**GUDE LANDFILL REMEDIATION**

**DEP, EA ENGINEERING & MDE MEETING**

# Gude Landfill – Nature and Extent Study MDE Comments / County Responses

## Documentation to Prepare Amendment No. 1

FIGURE-A  
NATURE AND EXTENT STUDY AMENDMENT NO. 1  
PROPOSED ADDITIONAL GROUNDWATER MONITORING LOCATIONS

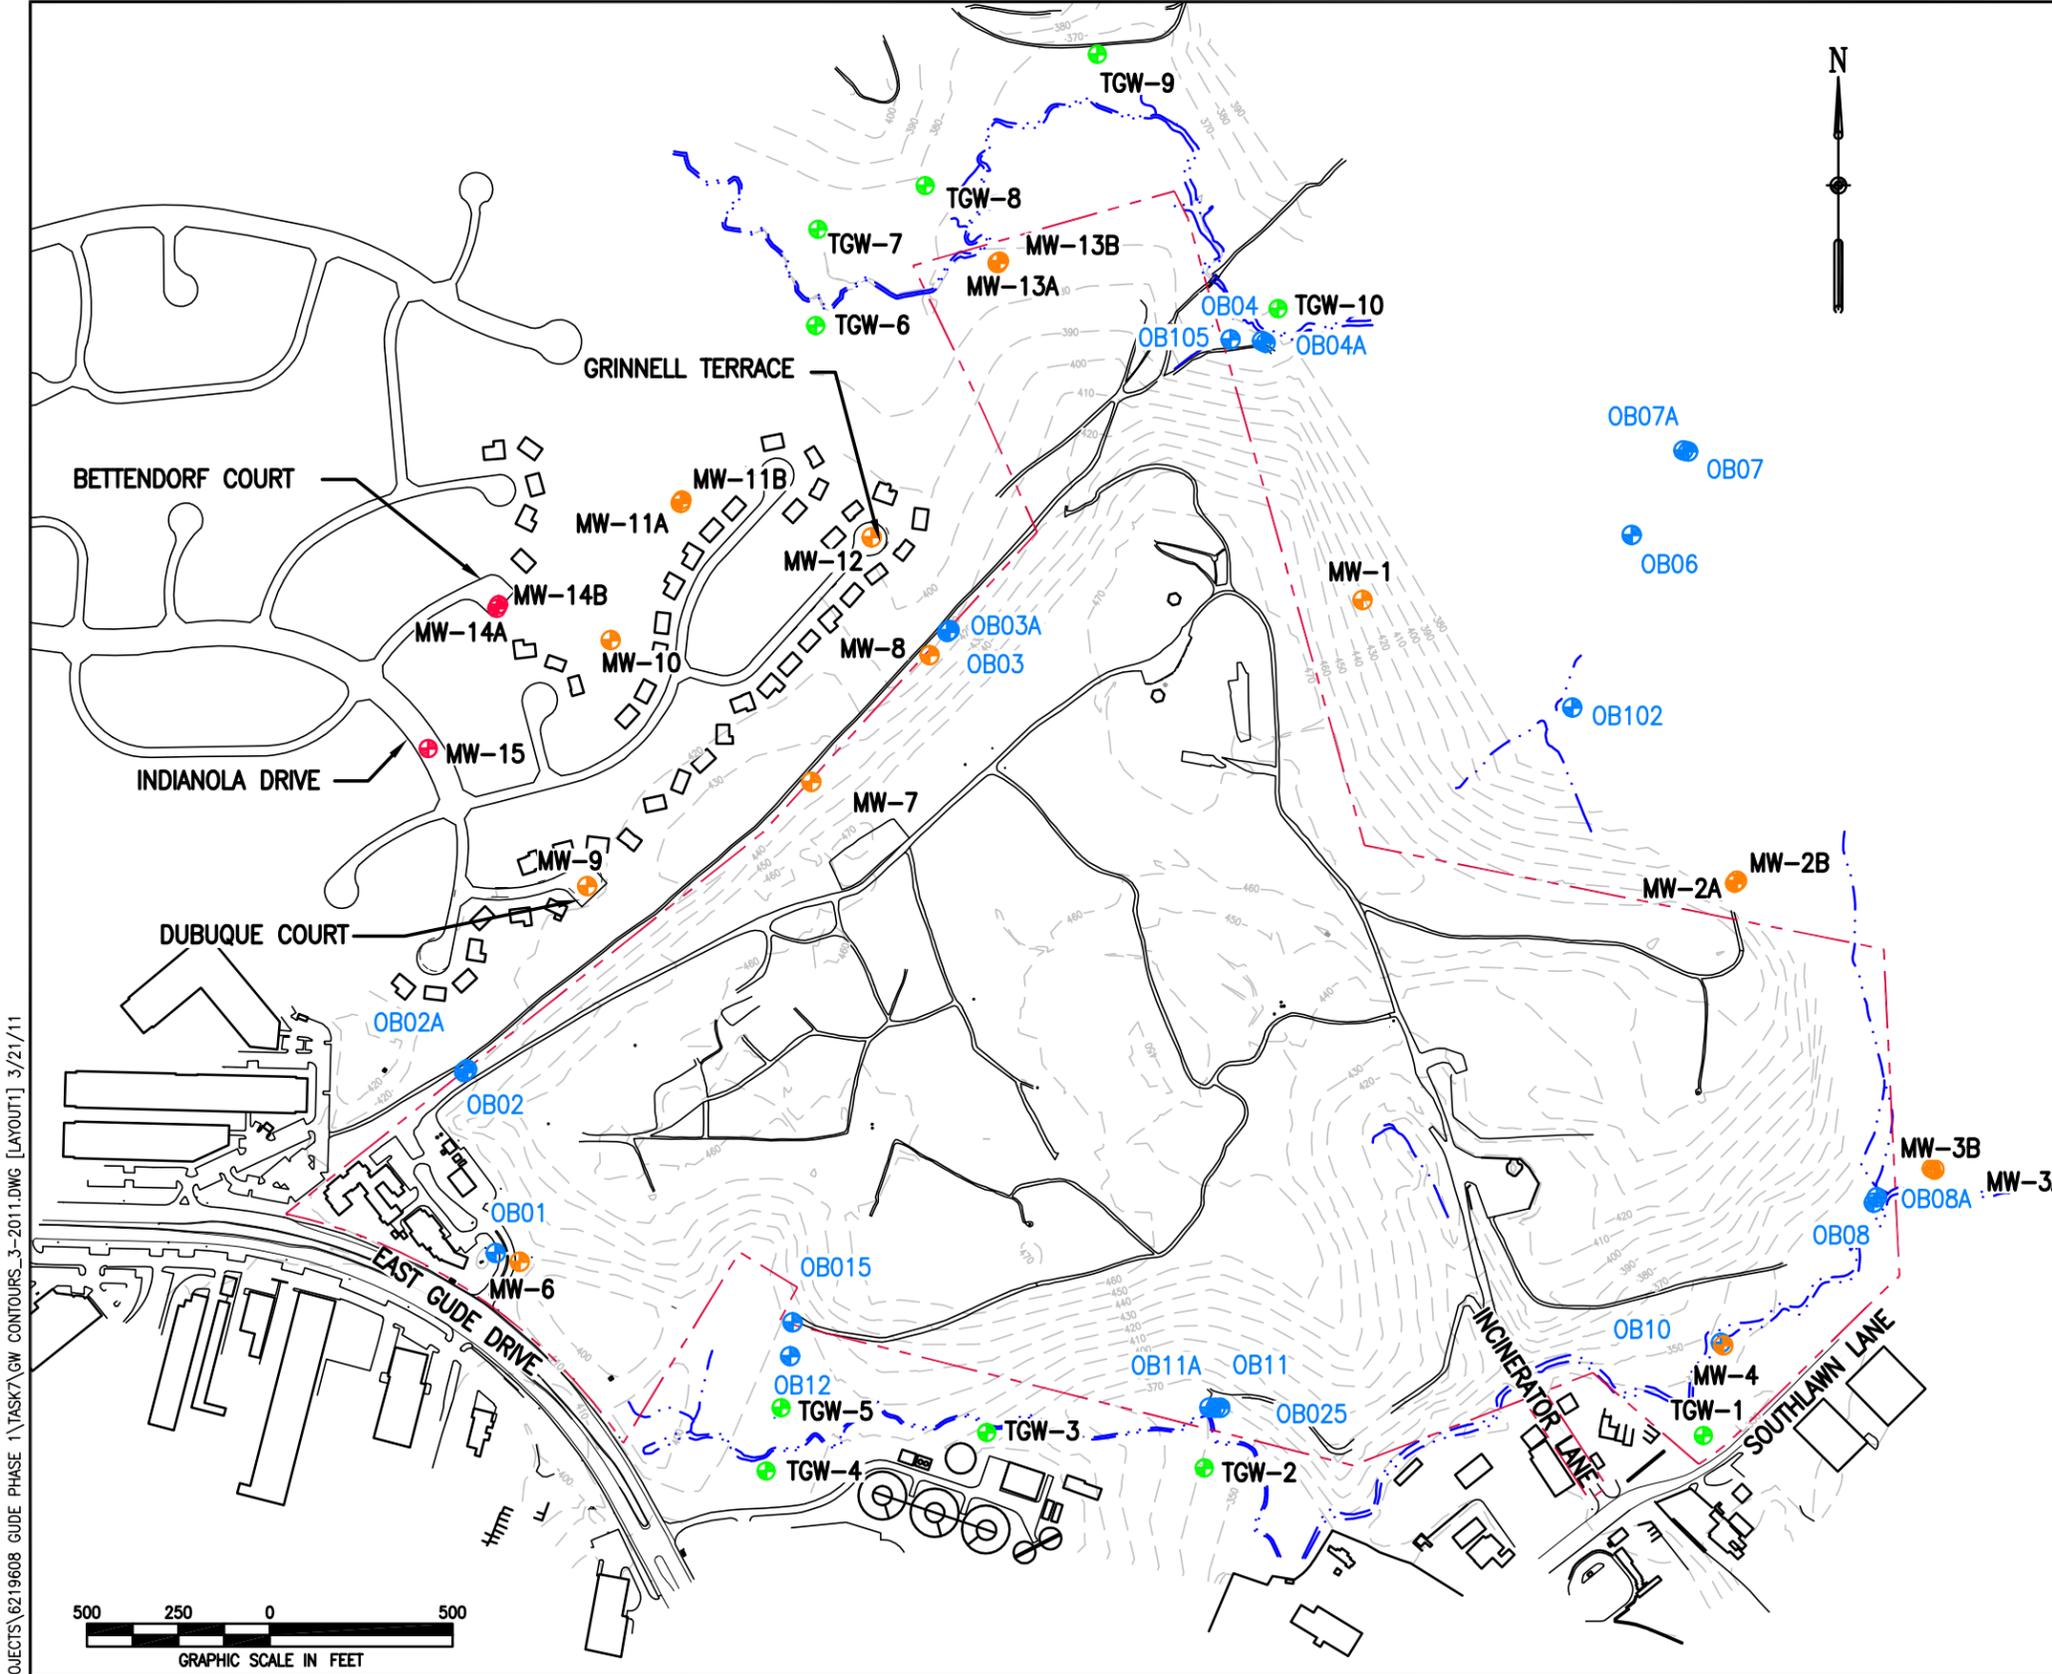
3) ***MDE – Maximum contaminant level (MCL) exceedances were noted at the Landfill property boundary, beyond the waste footprint and in the Derwood Station Community. The extent of MCL exceedances need to be further evaluated and characterized through additional groundwater sampling and analyses in the following areas of the Landfill site: northwest, northeast, south-central and southeast. Seasonal variation trends in the groundwater sampling data (e.g. fluctuations in constituent concentrations) should also be considered and evaluated.***

- County – Will further assess and bound the extent of potential impacts to groundwater through additional sampling and analyses in the following areas of and in vicinity of the Landfill site: northwest, northeast, south-central and southeast.
- County – Will acquire the necessary permits and land approvals to install and monitor three (3) proposed additional groundwater monitoring wells in the Derwood Station Community, which are to be located northwest of the Landfill property. MW-14A/14B

are proposed to be installed in Bettendorf Court (shallow/deep well pair down gradient of MW-9). MW-15 (shallow well cross-gradient of MW-9) is proposed to be installed near the intersection of Indianola Drive and Grinnell Drive. The groundwater monitoring wells will be installed using hollow stem auger and/or air rotary drilling techniques: Refer to Figure A – Proposed Additional Groundwater Monitoring Locations.

- County – Will acquire the necessary permits and land approvals to install and monitor ten (10) proposed temporary groundwater monitoring locations, which are to be located northwest (MW-13A/13B), northeast (OB105, OB04, OB04A), south-central (OB15, OB12, OB11, OB11A, and OB025) and southeast (OB10 and MW-4) of the Landfill property adjacent to and on opposing sides of the neighboring surface water bodies (Crabbs Branch Stream and Southlawn Branch Stream) in areas that may not be accessible by traditional drilling equipment. The proposed temporary groundwater monitoring locations will be installed by either direct push (geo-probe) equipment or through hand augering and will be installed to depth that penetrates the groundwater surface. Refer to Figure A – Proposed Additional Groundwater Monitoring Locations.

FIGURE-B  
NATURE AND EXTENT STUDY AMENDMENT NO. 1  
PROPOSED STREAM GAUGE LOCATIONS

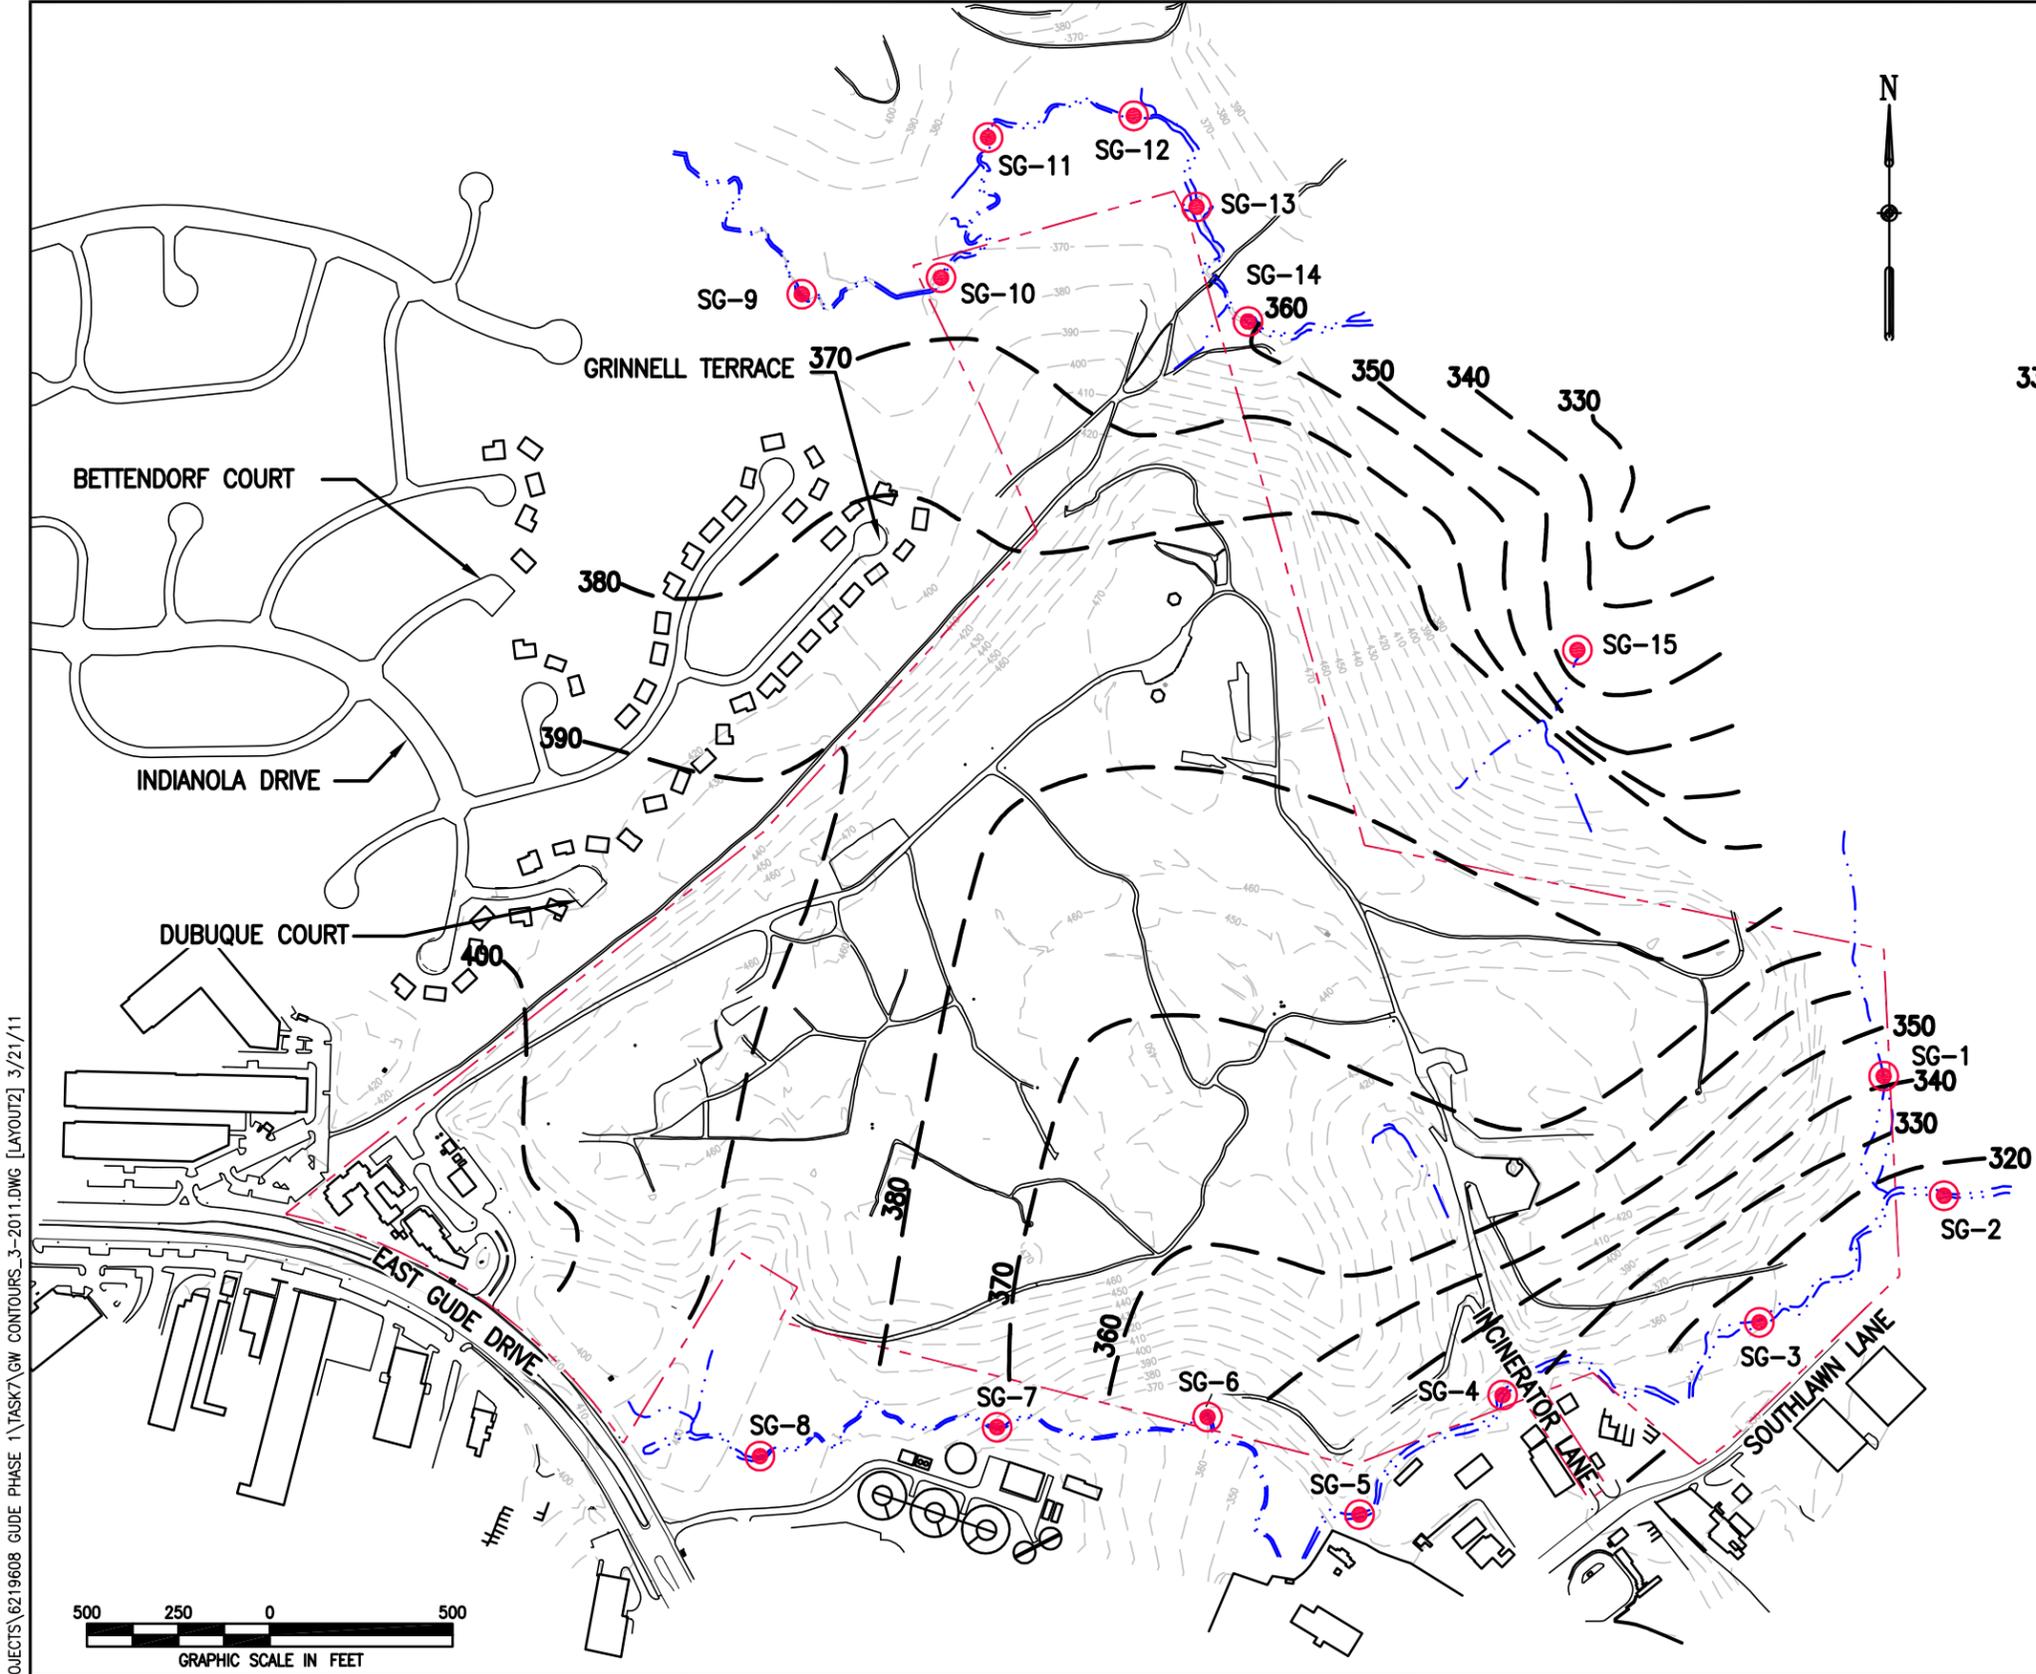
**9) MDE – *The NES Report groundwater contour map and related text should more closely reflect aspects of the Landfill's topography and the apparent flow direction of surface water bodies along the perimeter Landfill property boundary. More localized (e.g. radial) groundwater flow components in these areas of the Landfill site should be provided in an attempt to close the groundwater contours. Surface water elevations from bordering streams should be measured and included in the groundwater contour details.***

- County – Will install approximately fifteen (15) temporary stream gauges in the surface water bodies along the perimeter Landfill property boundary to obtain stream elevation data for incorporation into the groundwater contour map. The stream gauges will be tied into the Landfill site topography through field survey from the existing groundwater monitoring wells along the northwest/northeast, and south central/southeast Landfill property boundary. Refer to Figure B – Proposed Stream Gauge Locations.

- The groundwater contour map will incorporate the relationship of site topography and the apparent flow direction of surface water bodies along the perimeter property boundary of the Landfill. Where possible, more localized (e.g., radial) groundwater flow components will be addressed in these areas of the Landfill site in an attempt to “close” the groundwater contours.
